MP-2012-04(008)/ 306650301000
Attala County(ies)

PROJECT: MP-2012-04(008)/306650301 - Attala

SUPPLEMENT TO SPECIAL PROVISION NO. 907-618-4

PROJECT: MP-2012-04(008) / 306650301 -- Attala County

ADDITIONAL TRAFFIC CONTROL SIGNS REQUIRED:

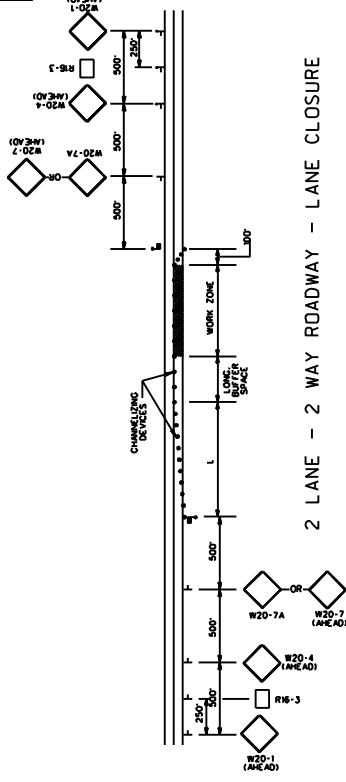
After the first paragraph of Subsection 907-618.01.2 on page 1, add the following.

Additional traffic control devices will be required as follows.

- 25 - W20-1 "AHEAD" signs required. One (1) W20-1 "AHEAD" sign is required at each local road or street entering the project.
- 70 - R4-1 "DO NOT PASS" signs required.
- 55 - R4-2 "PASS WITH CARE" signs required.
- 70 - W14-3 "NO PASSING ZONE" signs required.
- 8 - R16-3 "SPEEDING FINES DOUBLED" signs required.

R4-1 "DO NOT PASS", R4-2 "PASS WITH CARE", and W14-3 "NO PASSING ZONE" signs are required in accordance with Subsection 618.03.3, this drawing, and as specified in the Manual on Uniform Traffic Control Devices.

All construction signs and barricades shown on this page shall be included in the bid price for Pay Item 618-A, Maintenance of Traffic. Fluorescent orange sheeting shall be used on all construction and traffic control signs except for R16-3, R4-1 and R4-2 signs which shall be black legend and border on white background.

LOCATION OF R16-3 SIGNS

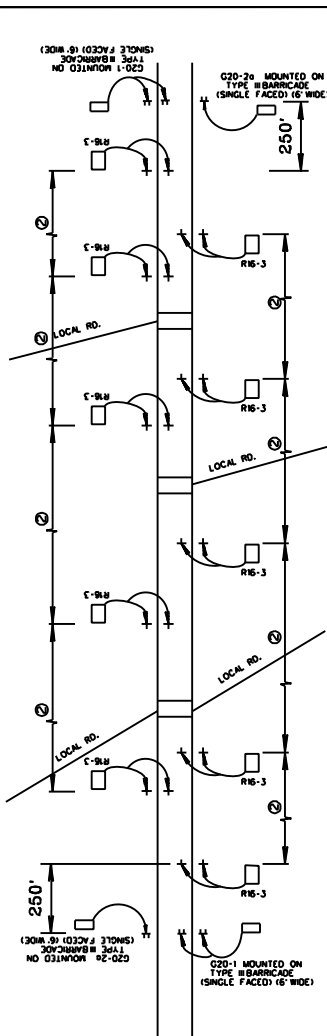
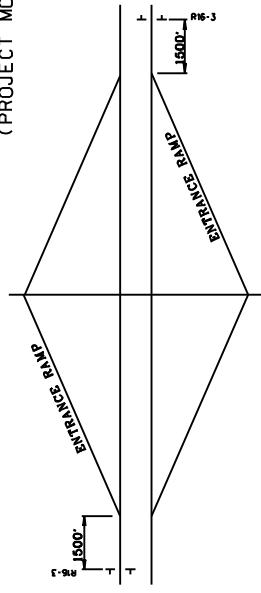
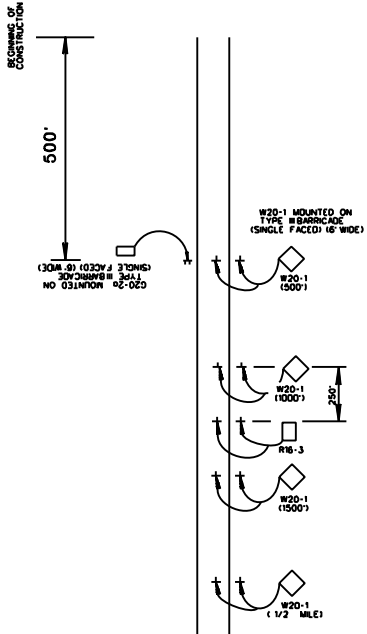
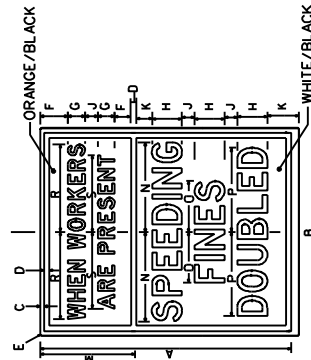
R16-3 signs shall be spaced in accordance with sheet titled "Location of R16-3 Signs".

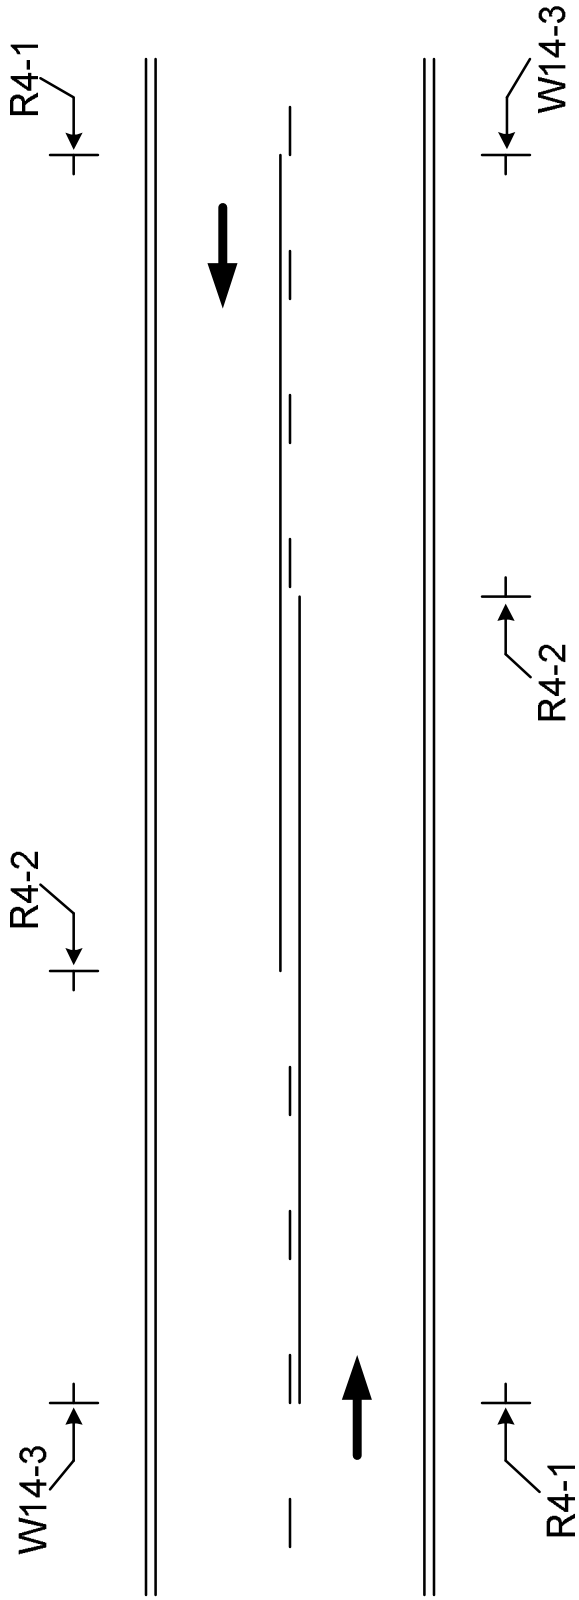
The W14-3, No Passing Zone sign, shall be placed on the left side of the road at the beginning of each no passing zone.

The R4-1, Do Not Pass signs, shall be placed on the right side of the road at the beginning of the no passing zone. Additional R4-1 signs shall be placed right and left in increments of 750 to 1000 feet throughout the length of the no passing zone.

The R4-2, Pass With Care sign, shall be placed on the right side of the road at the end of the no passing zone.

The R4-1, R4-2 and W14-3 signs are to be used when standard pavement markings are not in place. The signs may also be used to emphasize pavement markings.
